Proposed Technical Specification Changes
IPN-84-13

NEW YORK POWER AUTHORITY
INDIAN POINT 3 NUCLEAR POWER PLANT
DOCKET NO. 50-286

Safety Evaluation
Related To
Proposed Technical Specification Changes
IPN-84-13

FIGURE 6.2-2

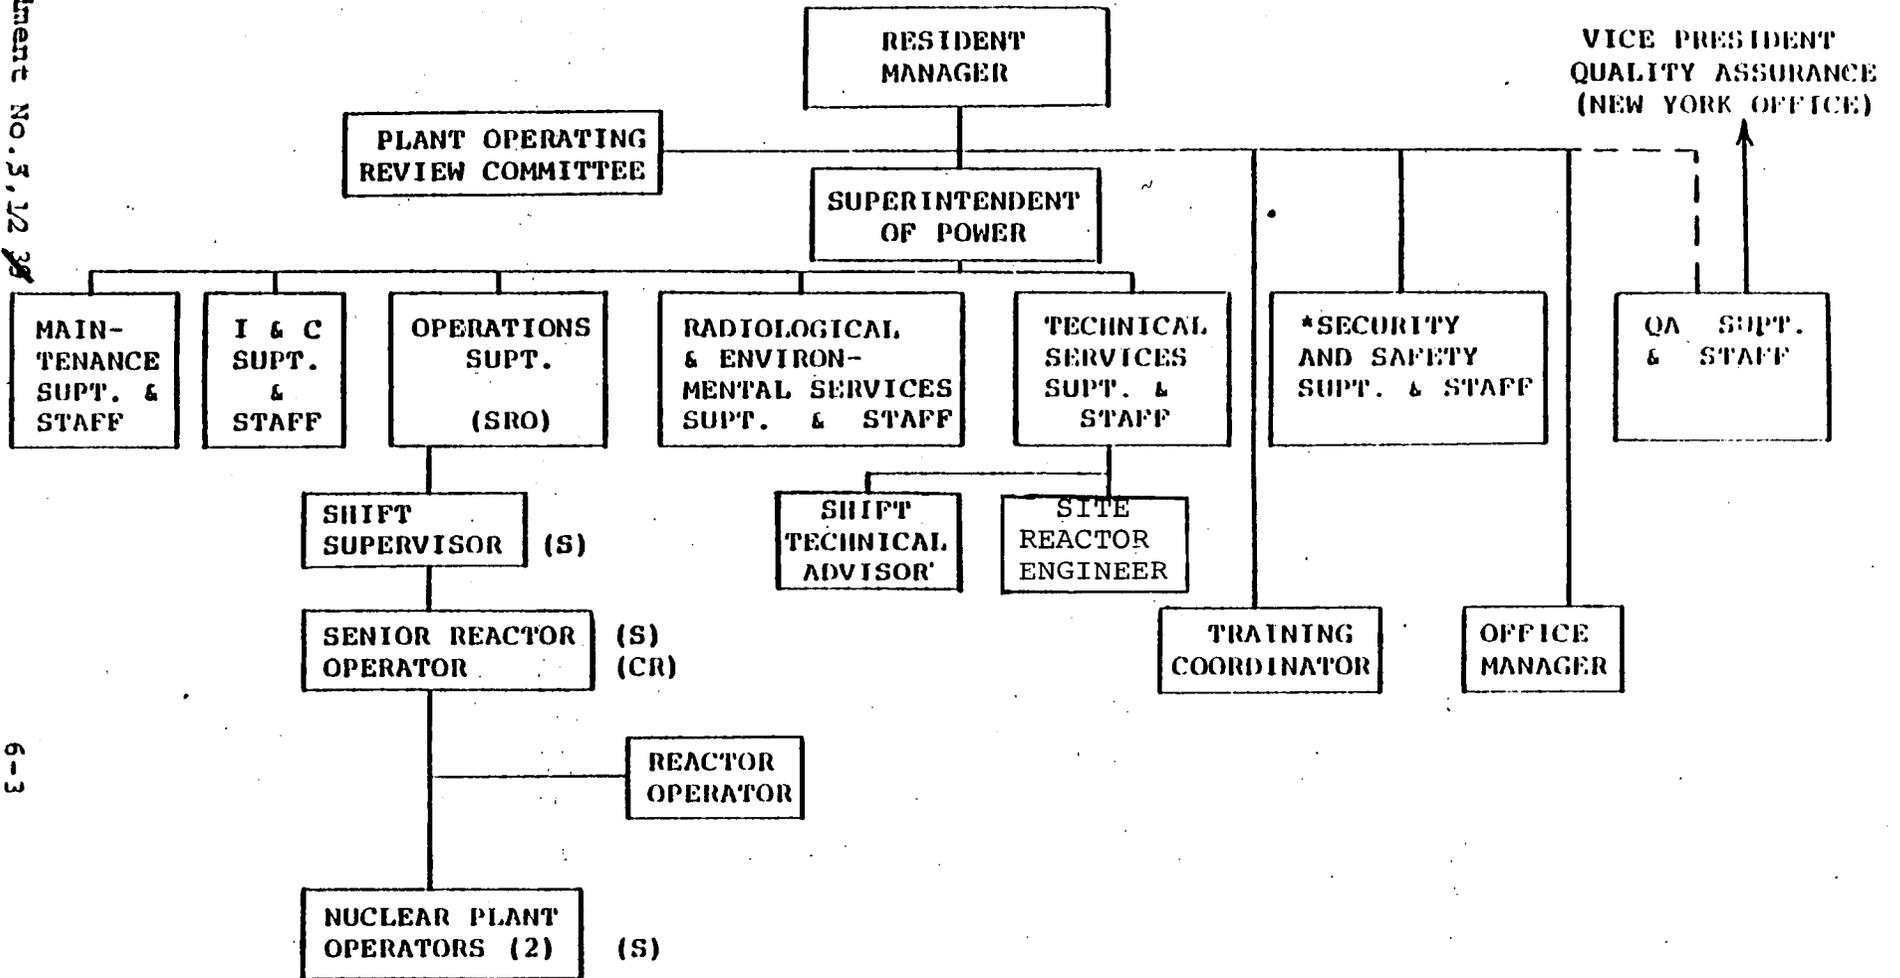
Sections 1 ("Definitions") and 6 ("Administrative Controls") of Appendix A to the Technical Specifications are being amended commensurate with Generic Letter No. 83-43 ("Reporting Requirements of 10 CFR 50, Sections 50.72 and 50.73, and Standard Technical Specifications") dated December 19, 1983. In addition, Figure 6.2-2 is being amended to more accurately reflect current plant organization and Sections 6.5.2.2, 6.5.2.3, and 6.5.2.6 are being amended to reflect proposed changes in the SRC's membership composition.

The changes proposed commensurate with Generic Letter No. 83-43 provide for Technical Specification compliance with the new LER regulation as promulgated per 10 CFR 50.73. The change proposed for Figure 6.2-2 does not change the staff organization at IP-3 but rather is intended to more accurately reflect this organization. The change proposed regarding SRC membership composition is intended to facilitate greater availability of the Vice-Chairman in the event the Chairman is unavailable for Special Meetings and to provide for an Alternate Vice-Chairman in the event both the Chairman and Vice-Chairman are unavailable for Special Meetings.
